SOLICITATION AMENDMENT
MODIFICATION DE L'INVITATION

Title - Sujet Aircraft Training / Maintenance Pla	
Solicitation No. - N° de l'invitation W0125-17LM01/A	Amendment No. - N° modif. 004
Client Reference No. - N° de référence du client W0125-17-LM01	Date 2016-07-27
GETS Reference No. - N° de référence de SEAG PW-\$KIN-930-6947	
File No. - N° de dossier KIN-6-46022 (930)	CCC No./N° CCC - FMS No./N° VME
Solicitation Closes - L'invitation prend fin at - à 02:00 PM on - le 2016-08-16	
F.O.B. - F.A.B. Specified Herein - Précisé dans les présentes	
Plant-Usine: <input type="checkbox"/> Destination: <input type="checkbox"/> Other-Autre: <input checked="" type="checkbox"/>	
Address Enquiries to: - Adresser toutes questions à: Littlefield, Mike	Buyer Id - Id de l'acheteur kin930
Telephone No. - N° de téléphone (613) 545-8058 ()	FAX No. - N° de FAX (613) 545-8067
Destination - of Goods, Services, and Construction: Destination - des biens, services et construction:

Aircraft Training and Maintenance Platforms

Amendment 003 is being issued in response to Bidder's questions and Canada's responses and to amend Annex "A" Statement of Work.

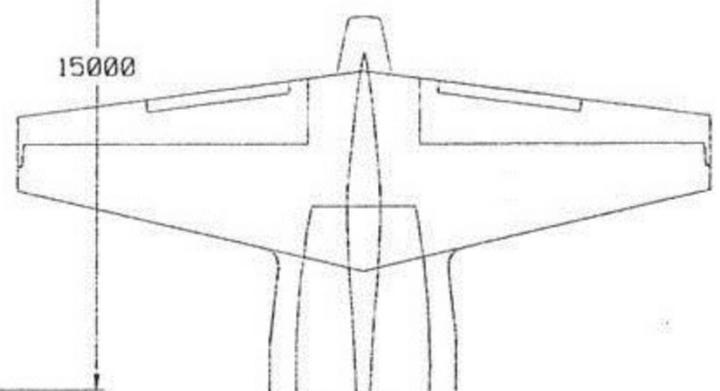
You refer to pre-existing maintenance stands. Is this the control center referred to in 1.2? And is more detail of these stands available?

A3. Please see answer for Question#1. The pre-existing stands have a rolled stairway to access the maintenance stands and should be considered as a standalone work area. There is no specific requirement for new stands to attach to pre-existing stands. The pre-existing stands extend to the tailpipe area to make a complete walk around area when personnel are on those stands. See pictures.

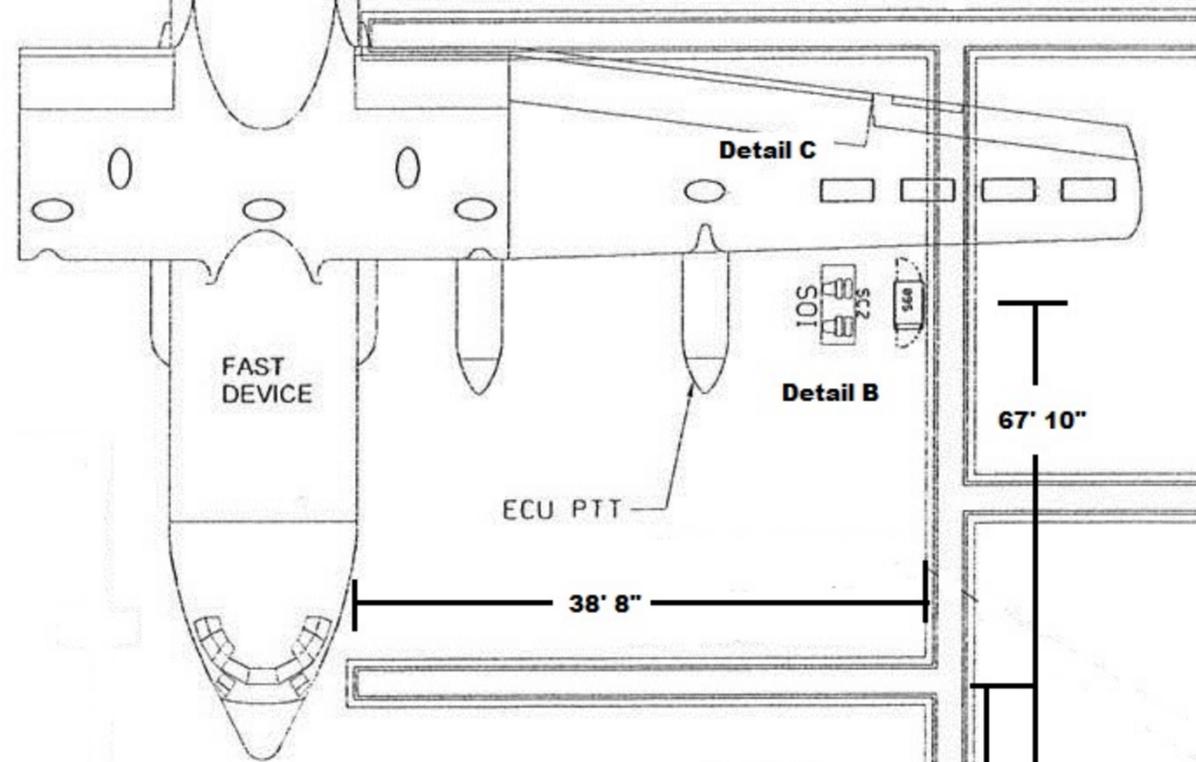
Q7. Reference Annex A Statement of Work Section 3.2.1 (o)
Please provide floor dimensions for concrete trenches as they relate to layout of the aircraft. (Annex E and Annex F).

Can you provide wing jacking locations? Does the tail have jacks? If so, can you provide the locations?

A7. Looking at Annex E, the trench starting at the nose of the aircraft is approx. 40 ft./12.2 metres in length with an additional 8 ft./2.4 metres from where the trench ends to the fuselage of the aircraft. The length of the trench from front to back is 54 ft./16.5 metres long. The trench that extends behind the aircraft wing is approx. 48 ft./14.6 metres in length. The trench is approx. 32 inches/82 cm wide. See diagram.

A16. The wing jacking locations are on the R/H wing side outboard of the blank engine space. This allows minimal movement of maintenance stands to allow Jack to be positioned. Aircraft cannot be jacked as it is permanently mounted to 4 cradles on the belly of the aircraft. See diagram and pictures.
